Informal document No. GRSG-97-32-Rev.2
(97th GRSG, 20-23 Oct. 2009
agenda item 5)

Proposal for draft amendments to Regulation No. 118 (Burning behaviour of Materials)

Example 2

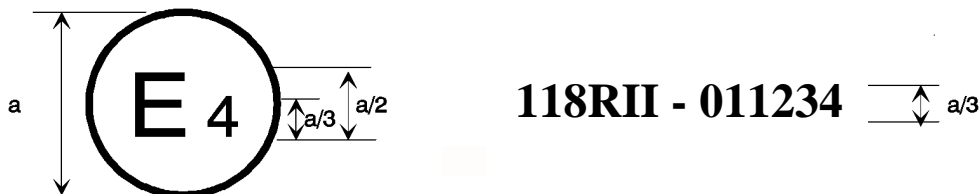
The above approval mark affixed to a component shows that the type concerned was approved in the Netherlands (E4) pursuant to Part II of Regulation No. 118 under approval number **011234**. The first two digits (**01**) of the approval number indicate that the approval was granted in accordance with the requirements of the **01 series of amendments to Regulation No. 118**.

Figure 4a
Apparatus for testing the capability to repel fuel or lubricant
(Dimensions in millimeters)"

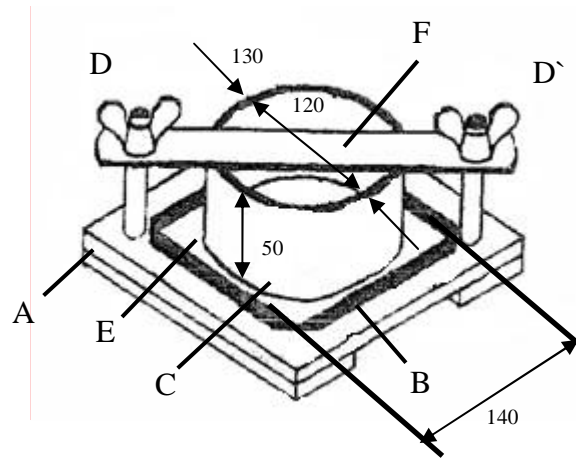
3. Apparatus (see figures 4a and 4b)

EA a seal base plate, with a hardness of at least 70 Shore D.

AB ~~a base plate with an~~ absorbant surface on the baseplate (e.g. paper);

BC a metal cylinder (inner diameter of 120 mm, outer diameter of 130 mm, height of 50 mm), filled with the test liquid;

~~C-C~~ **D-D'** two screws with wing nuts;

~~DE~~ the test sample;

F top plate
